OIL - ENGINE OIL SCAVENGE PUMP COUPLING REDESIGN

79 - 22 - 41

V2500-ENG-79-0074

(fig. 01) SCAVENGE OIL PUMP

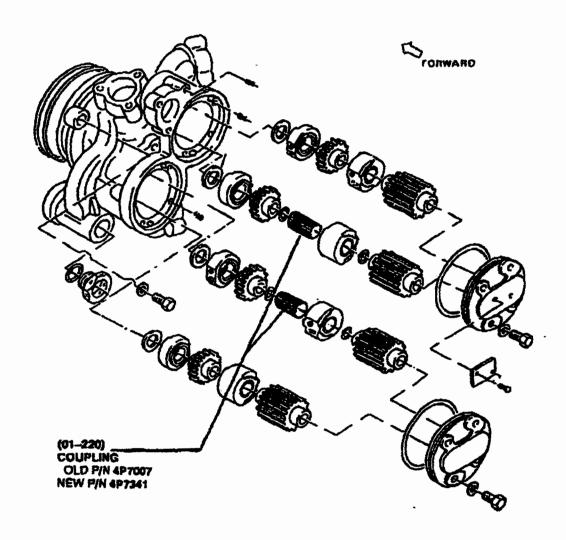
This Service Bulletin introduces a revised Oil Scavenge pump Coupling similar to the existing one except for:

- (1) Constant section with teeth all along.
- (2) No internal lightening hole.
